HISTORIC AND DESIGN REVIEW COMMISSION

HDRC CASE NO: 2022-240
ADDRESS: 114 DEWBERRY ST
LEGAL DESCRIPTION: NCB 6461 (MISTLETOE ADDITION SUBDIVISION), BLOCK 1 LOT 57
ZONING: R-4, H
CITY COUNCIL DIST.: 1
HIST. DIST. NAME: River Road
APPLICANT: David Pina/Grand Builders LLC
OWNER: PINA DANIEL & STEPHANIE
TYPE OF WORK: Construction of a 2-story residential structure
APPLICATION RECEIVED: April 22, 2022
60-DAY REVIEW: Not applicable due to City Council Emergency Orders
CASE MANAGER: Jessica Anderson

The applicant is requesting conceptual approval to construct a two-story residential structure on the vacant lot at 114 Dewberry.

Historic and Design Review Commission
Design Review Committee Report

SHEET NAME
PRELIMINAR SITE PLAN

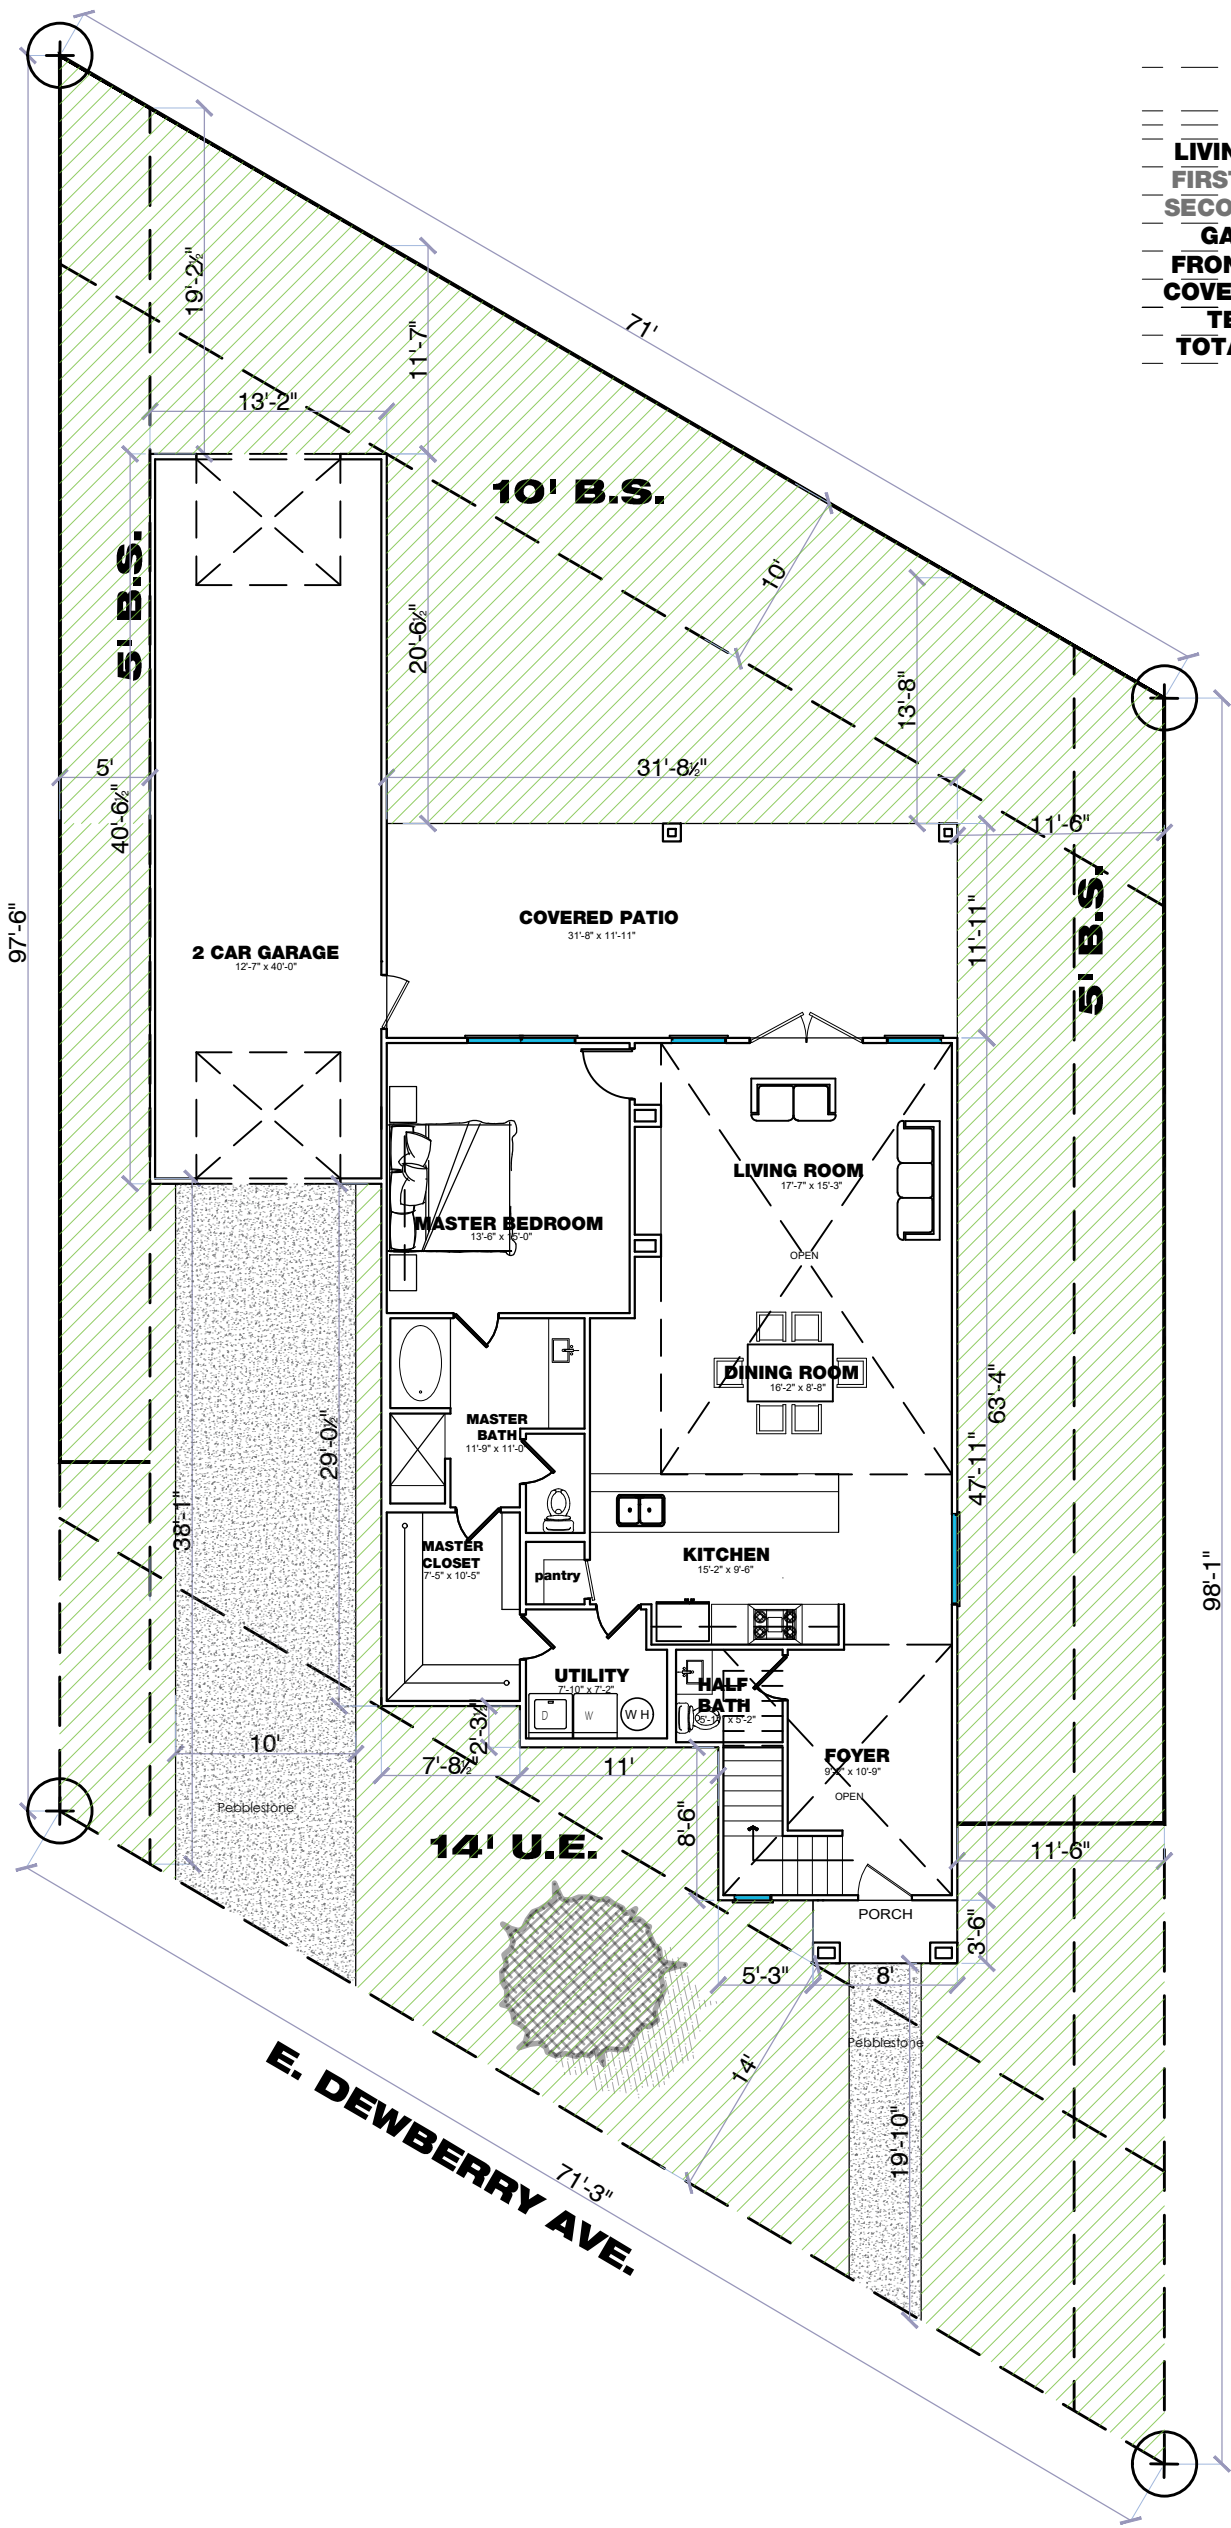
- Provide more context for the site plan. Submit photos of the properties on either side of the site as well as behind the site.
- Add directional arrows to the site plan.
- Request another DRC once plans are revised to include suggestions.

FRONT ELEVATION

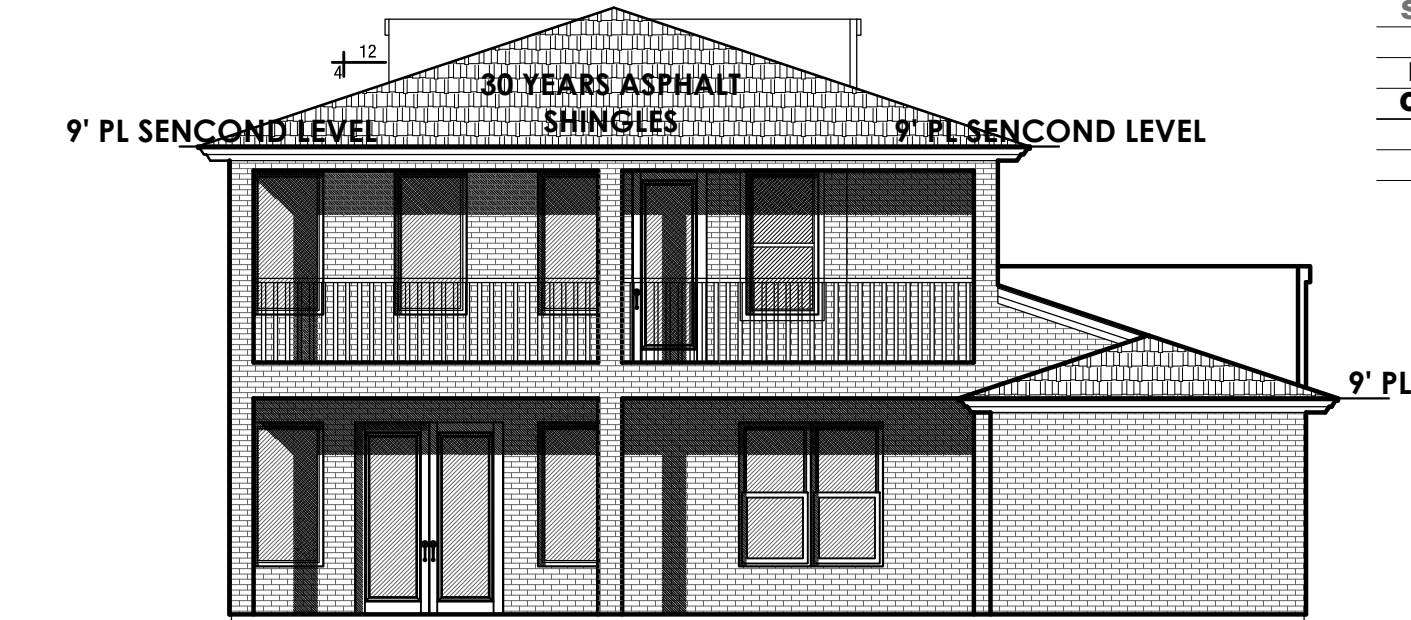
- Concerned about the lack of windows on the left and front elevations. Left elevation is a big blank wall—not typical in an historic district.
- Lots of large, blank walls—look at doing some detailing in the brick to imply windows or something to relieve the spans of brick.
- Regarding the height-and-a-half front porch: not an element found in historic districts. Typically see single- or double-height porches. This one is just a stoop.
- The scale and size of front porch is problematic—look to other houses in the neighborhood.
- Consider making the porch broader, deeper—a more usable space, like usable outdoor porches found in the historic districts.

- The first and second stories aren't legible.
- Not easy to see what's happening behind the varying wall heights.
- No windows to the left of the skinny vertical window on front elevation.

- Address wall spans without fenestration.
- Create a porch form more consistent with those found in the district.
- Provide more context for the site.
- Add directional arrows to the site plan.
- Request another DRC once plans are revised to include suggestions.

LEFT ELEVATION

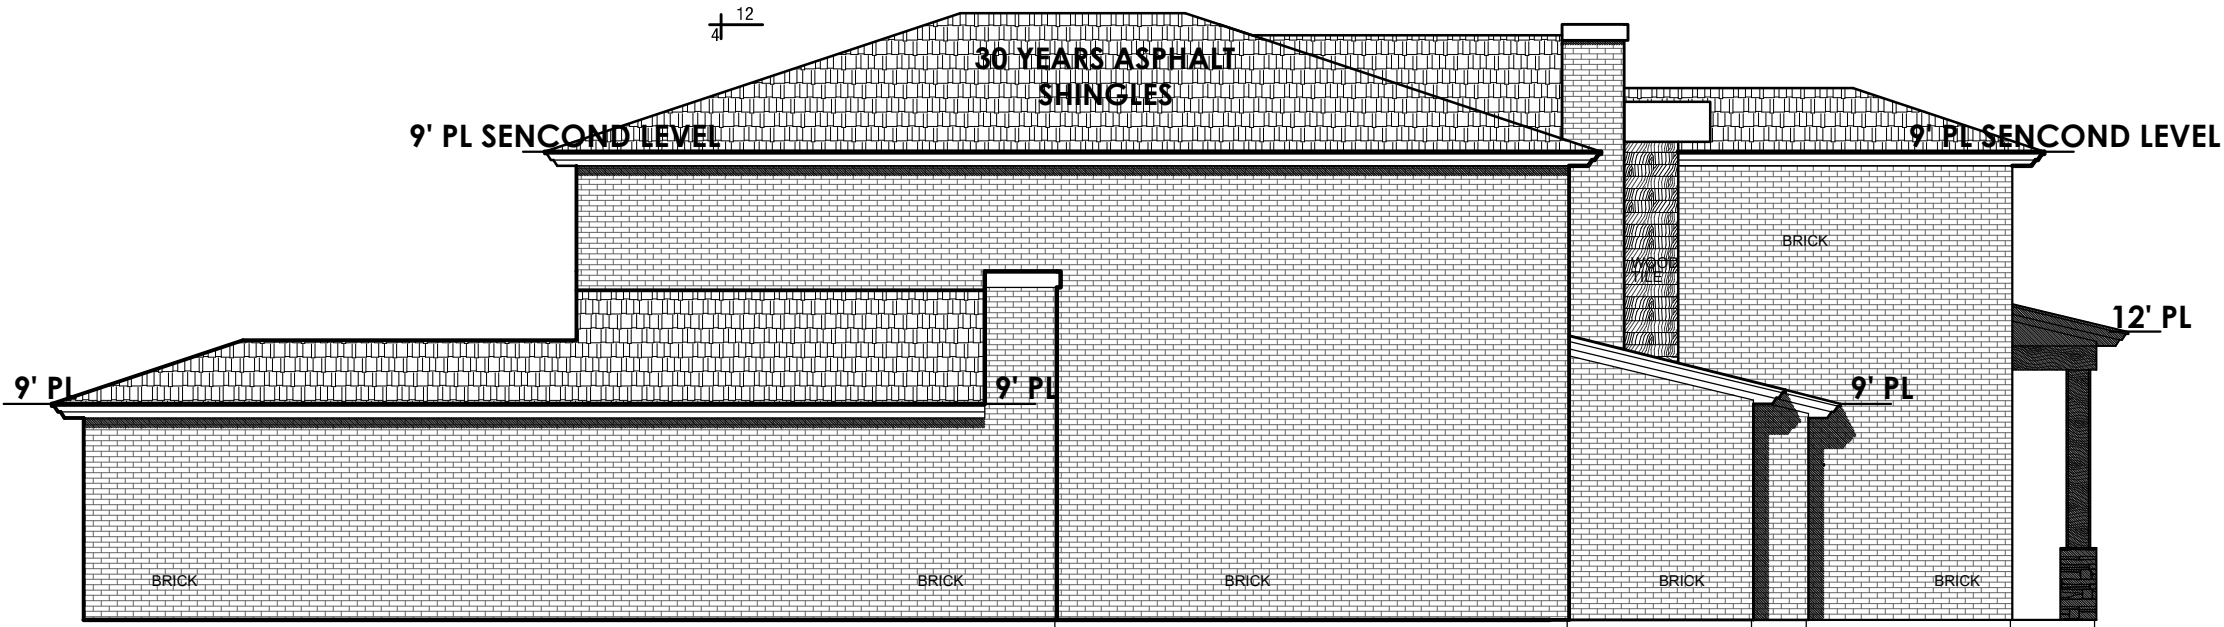
- Appears massive because of plate heights and varying roof forms.
- Suggests going through the guidelines regarding massing and plate heights.
- Historic porches and foundations are typically raised—there's a perimeter wall or pier and beam/raised house.
- Garages aren't typically attached.
- Look at other windows on other houses in the area.
- The rear elevation looks well-proportioned.

ROOF PLAN

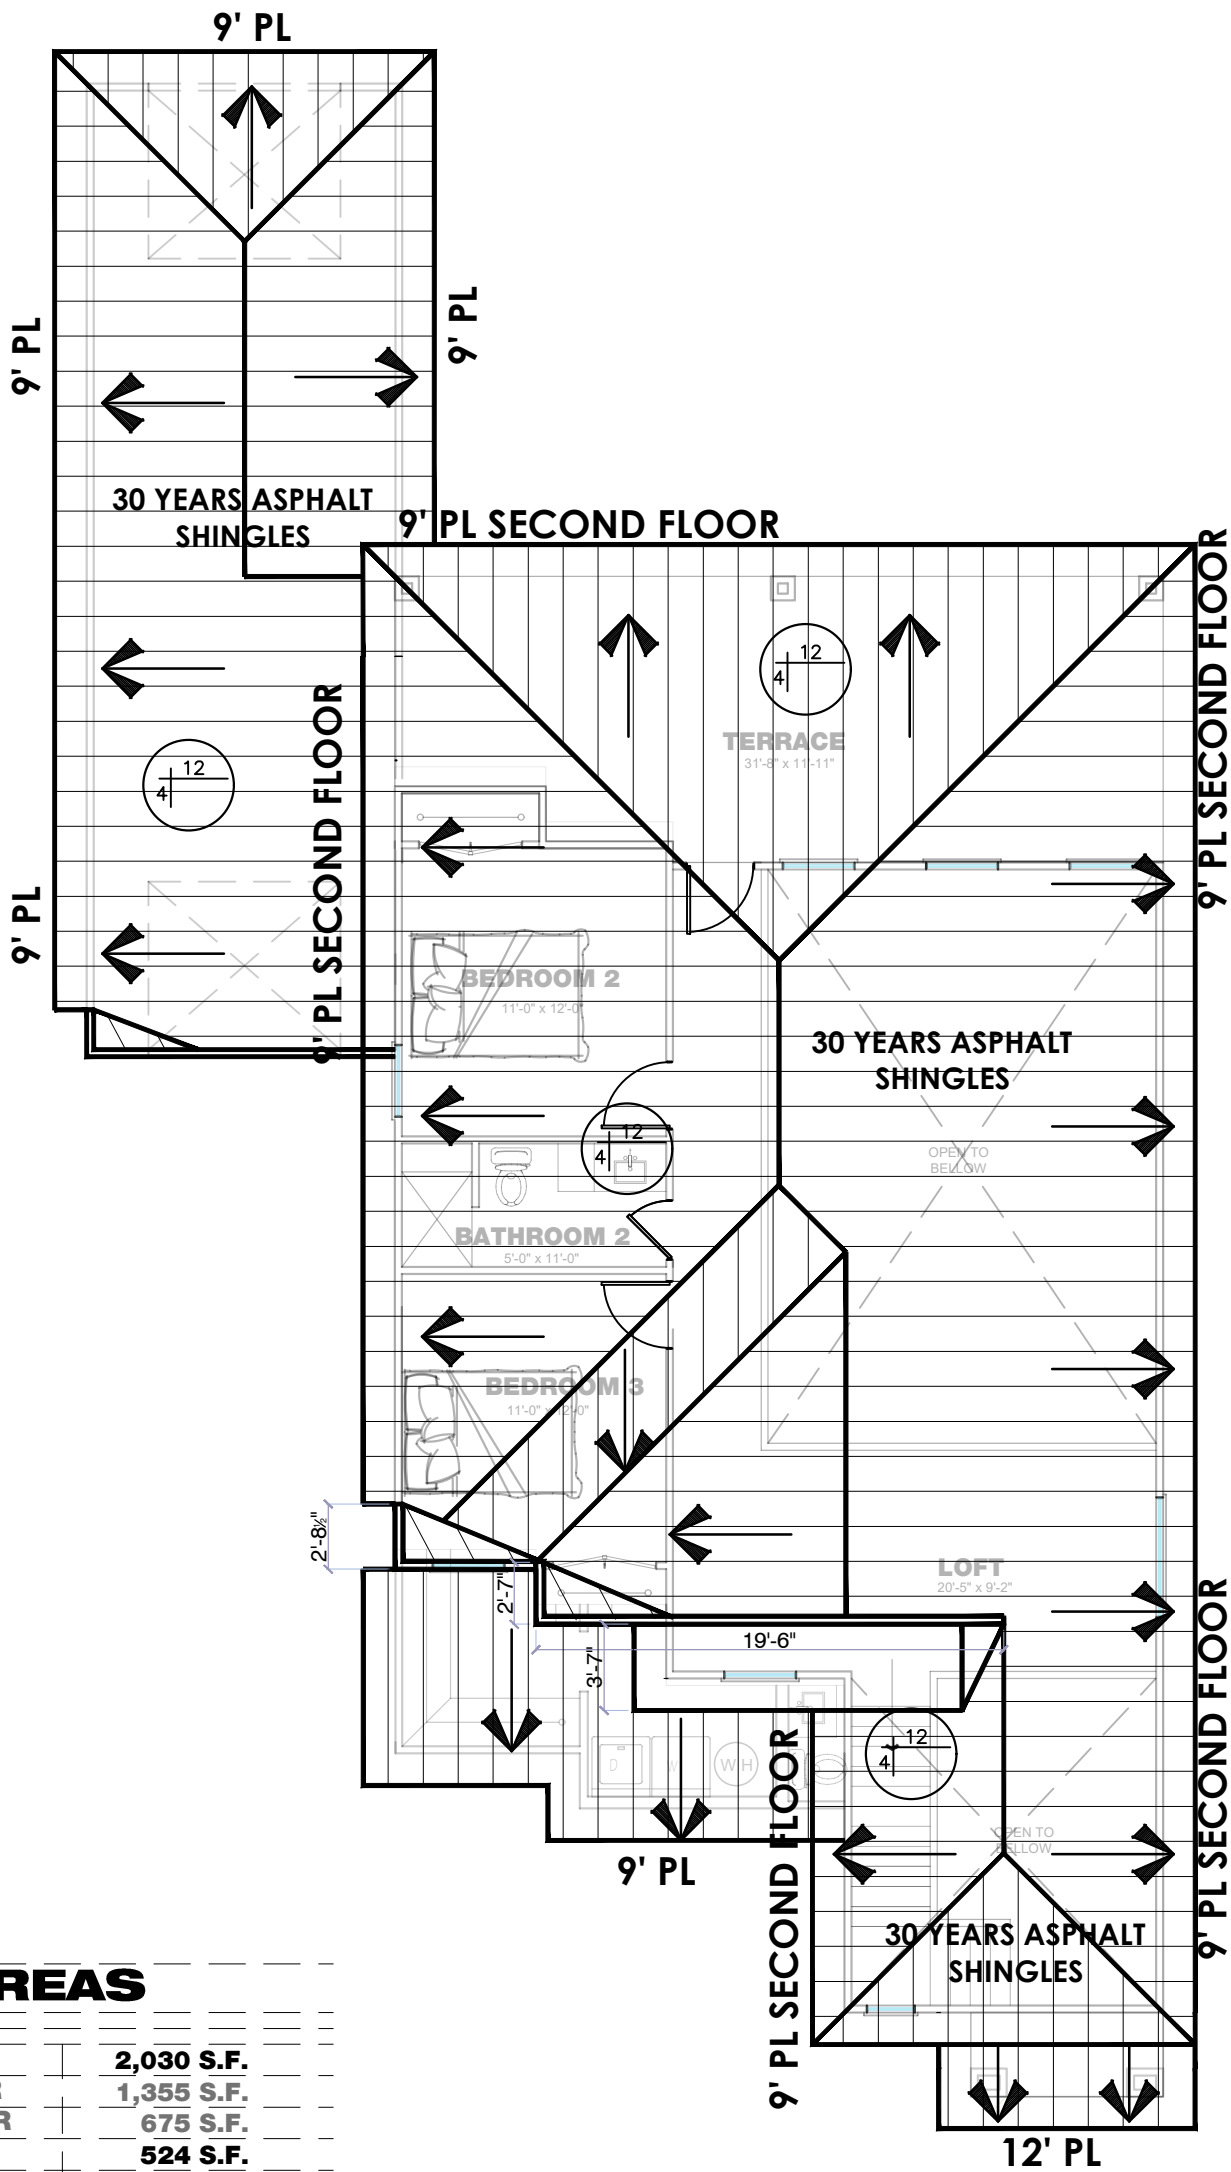
- h. **ROOF FORM** – The applicant has proposed a complex roof form comprised of hipped roofs clad in composition shingle with two parapets on the primary elevation. This is not consistent with the Guidelines for New Construction, as the Guidelines note that roof forms for new construction should be comparable with those found historically within the district. Historic residential structures within the River Road historic district feature gabled and hipped roofs.

- ii. That the applicant incorporate proposed massing and scale consistent with the Guidelines for New Construction, as noted in finding f.
- iii. That the applicant incorporate a roof form that is consistent with the Guidelines and historic examples found throughout the district, as noted in finding h.
